**DATE:** 04.08.2015  
**TO:** ProTrak  
**FROM:** Bill McDow  
Transportation Planning

■ **BO JANGLE'S COLLEGE RD [TRC Plan Review]**

☞ Initial Review Note ☞

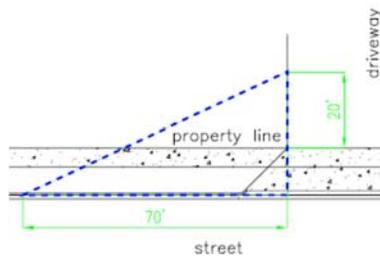
1. Driveways for lots along major thoroughfares must at least 75' offset from property lines to the curb line. This lot does not have the proper offset, a variance request may be required.

- The existing driveway curbing has been damaged by vehicles that overrun/ drive over the curb line. Please modify the radius and width of the entrance driveway to improve the turning movement for vehicles at this site.
